# **Eastern Creek Business Hub SSD 5175 MOD 5 & SSD 8858**

## **Statement of Reasons for Decision**

15 June 2020

Figure 3 Building 2 western façade, facing Rooty Hill Road South.  
 [Source: Drawing DA09 C Issue C, prepared by i2C]

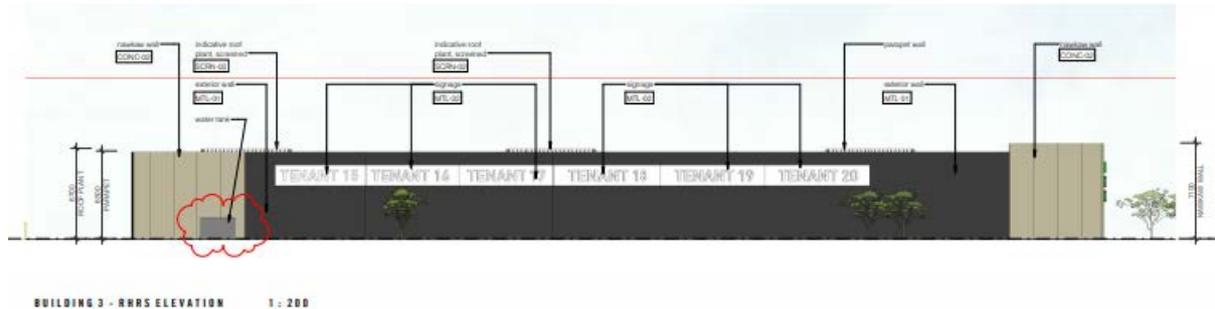
98. The dark areas shown in Figure 3 above are proposed to be profile metal cladding, and the lighter areas on the northern and southern ends are concrete ‘nawcaw’ finish. Notwithstanding that this building is well set back from Rooty Hill Road South, besides the signage, the façade is blank. This is not compliant with the Design Guidelines, including in Section 3.6.1 General guidelines (bold added):

- Objectives O2 Ensure that built form positively contributes to the existing streetscape of Rooty Hill Road South; and O7 **Encourage a high quality built form by encouraging visual interest on elevations fronting streets...**;
- Controls: C6 Provide articulated and well detailed elevations including the use of projections and recesses, variety of quality materials, externally expressed structures and framing systems, glazing, sun shade structures, colours and other forms of architectural detailing. **Blank building facades facing street frontages are not permitted.**

100. The Commission also asked how the largely blank wall of Building 3 responded to the Rooty Hill Road South street frontage. The Applicant was asked to consider amending the design of this façade (to comply with section 3.6.1 C3 of the Design Guidelines).
101. The Applicant's Response was as follows (an extract of the southern, and not the subject western elevation was also provided):

102. The Commission notes the Applicant's Response to questions with regard to this façade in paragraph 101 above. However, the view of the building from motorists is important (as well as pedestrians); and the landscaped setback is not sufficient to justify a blank building façade fronting Rooty Hill Road South. The improvement of the size of the footprint of the building in the Concept Plan as proposed to be amended is noted and supported as outlined in Section 5.2 above. However, the design of the building now to be constructed under SSD 8858 is the subject of separate assessment and determination.
103. The Commission therefore proposes to add Condition B28 to Schedule B of the Conditions of Consent for SSD 8858 to ensure that the design of this façade be improved to comply with the Eastern Creek Design Guidelines.

Figure 4: Additional Information provided to the Commission = Concept Passive Irrigation Drawing Issue M date June 2020, prepared by Arcadia

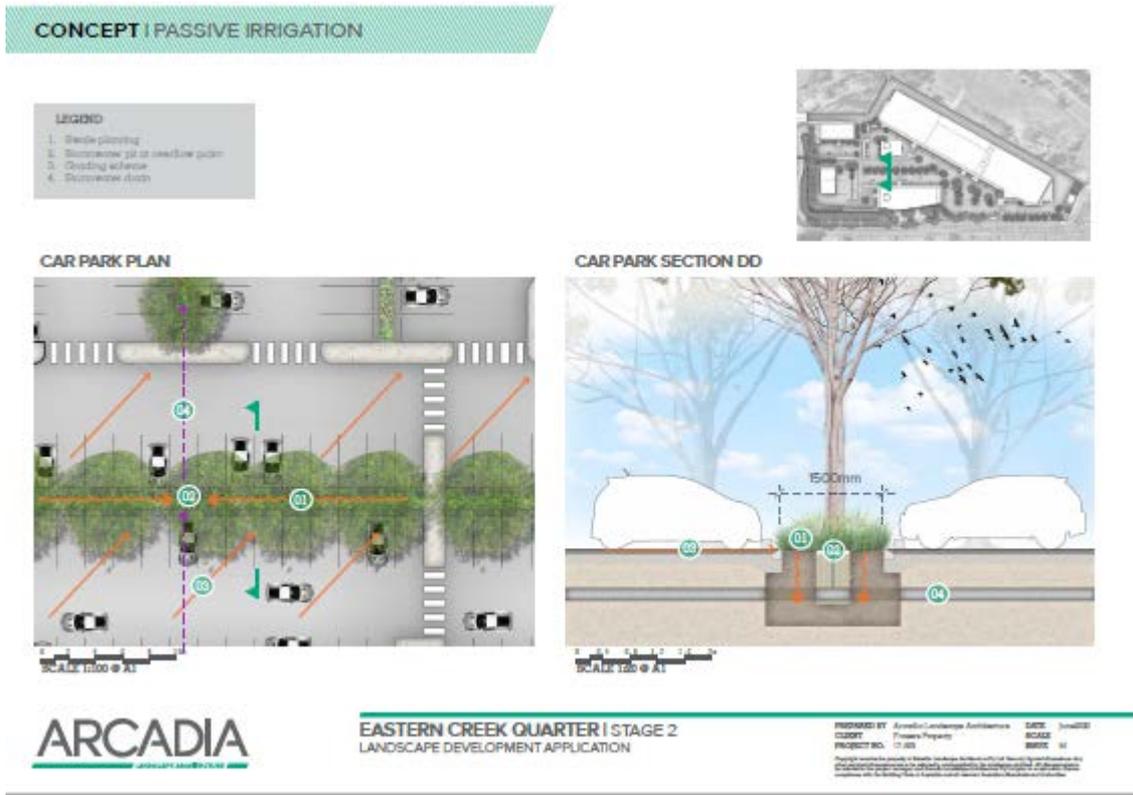
- 105. The Department in Appendix C of the AR referred to this condition, but only with reference to the landscape plans identifying the trees and plant species to be used (p50).
- 106. The Applicant's Response to the Commission's question was provided on 2 June 2020 and the Applicant provided the diagram in Figure 4 below showing swales between the car parking spaces. However, no details of the paving treatment around the buildings and within the car park is provided on the submitted landscape drawings, other than Drawings 200 – 203 and 640 Issue L, dated December 2019, which provides concept level detail only.
